# Lyle Falls Fish Passage Project

## Final Environmental Impact Statement

DOE/EIS-0397

November 2008

**Figure 3-8. Land Ownership.**

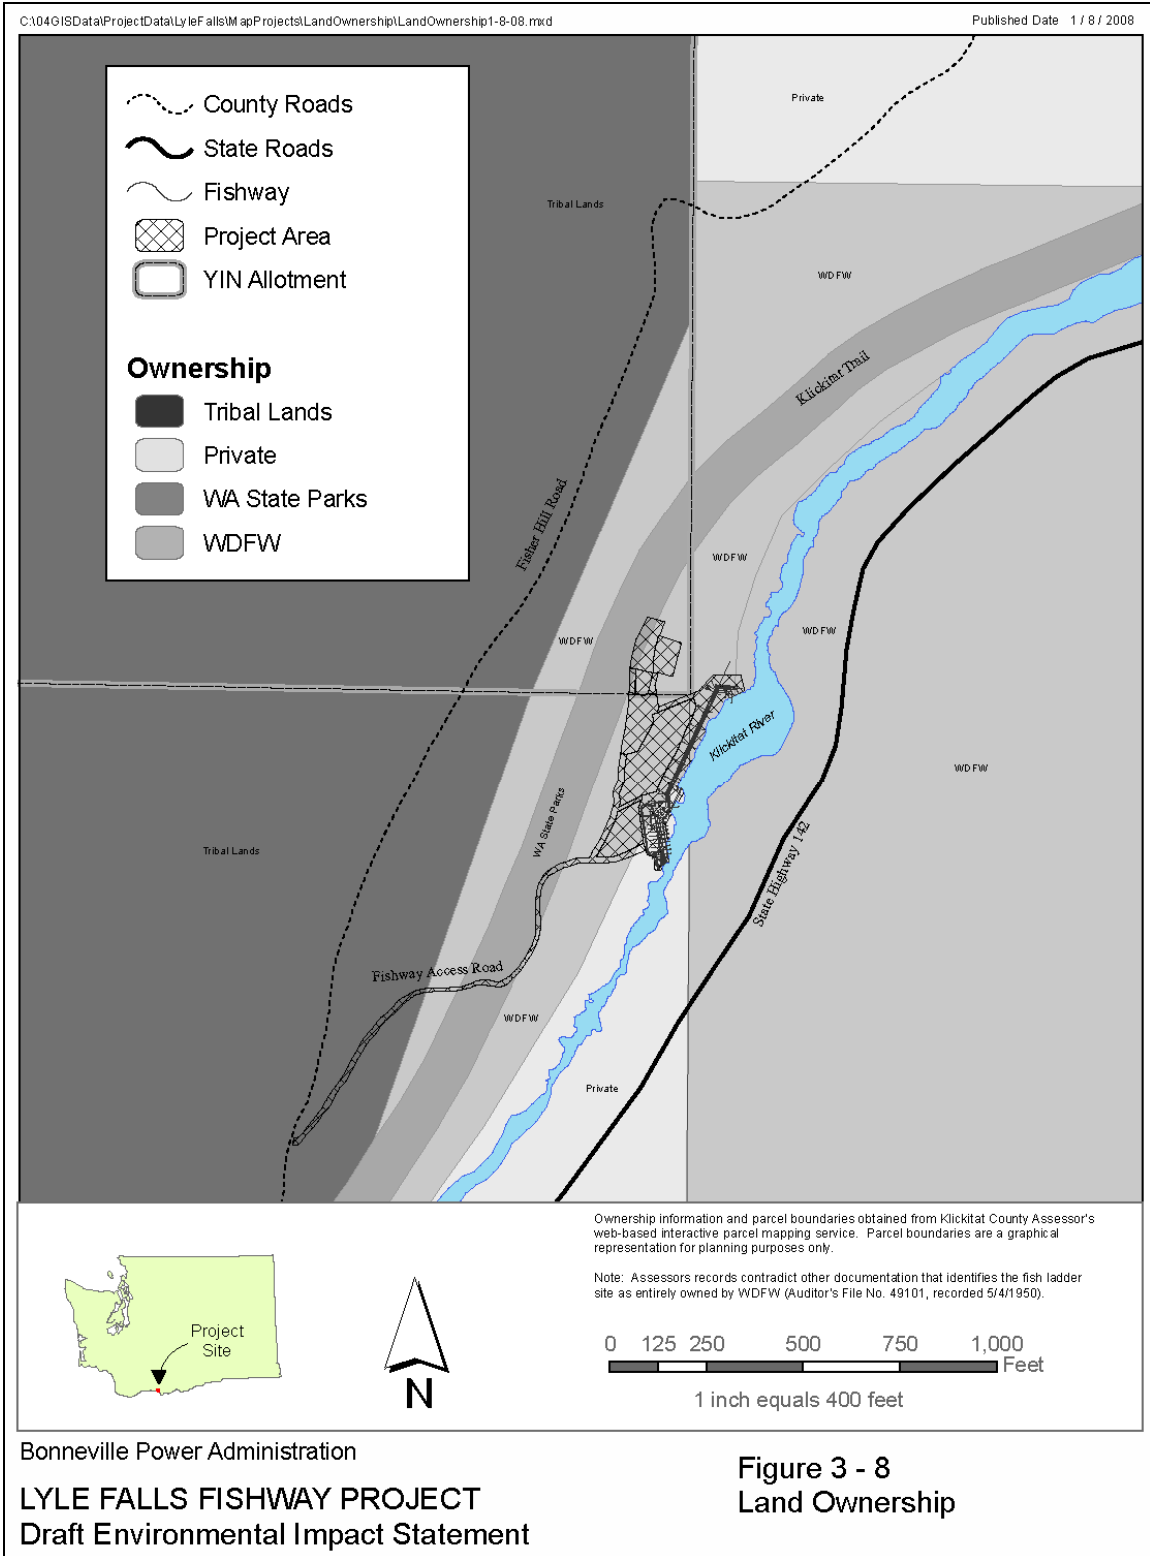
Figure 3-8 on **page 3-101** of the DEIS has been modified, extending the mapped coverage of the Klickitat River. It is included at the conclusion of this section (page 24).
